## Application for Licence Amendment

<b>Licence Number</b>	L8621/2011/1
<b>Licence Holder</b>	Roy Hill Iron Ore Pty Ltd
<b>ACN</b>	123 722 038
<b>File Number</b>	2011/009784-1
<b>Premises</b>	Roy Hill Iron Ore Mine  M46/518 and M46/519  NEWMAN WA 6753  As defined by the Premises maps attached to the Revised Licence
<b>Date of Report</b>	23 September 2022
<b>Decision</b>	Revised licence granted

**Figure 1: Remote MAR Indicative Bore Locations**

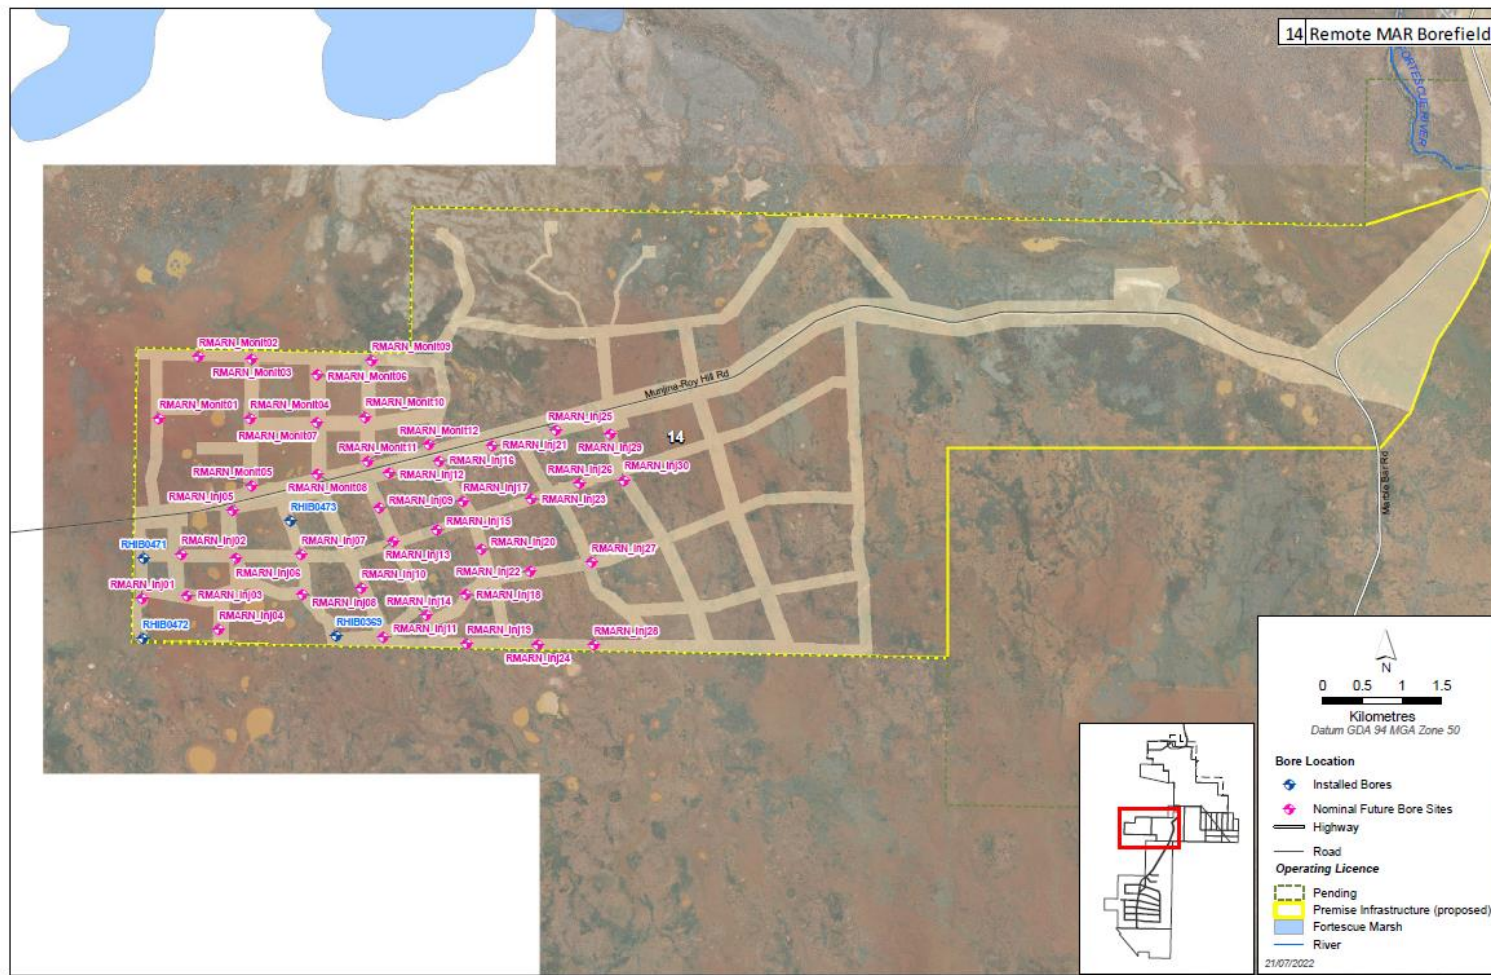
Condition	Summary of Licence Holder's comment	Department's response
	cannot be installed. There is no requirement for a replacement.	
Amendment Report		
Throughput	Roy Hill confirms all additions regarding Category 6 design capacity are correct.	Noted.
Figure 1	Roy Hill requests: Figure 1 is updated with Figure 18 from the Licence (once updated as discussed in Table 1)	Updated as requested.
Table 3: Licence Holder Controls	Roy Hill queries whether this should reference EPA Report 1716?	This is direct from the Licence Holder's supporting documentation and is referring to the <i>EPA Report 1484 - Environmental and Water Assessments Relating to Mining and Mining-related Activities in the Fortescue Marsh Management Area</i> .
Appendix 1	Roy Hill notes that the snipped information should have cited the following thresholds against TDS and TSS:  WMP Threshold Criteria  TDS is managed under the injection limit of 50,000 mg/L  TSS is managed under the injection limit of 75 mg/L	Noted.
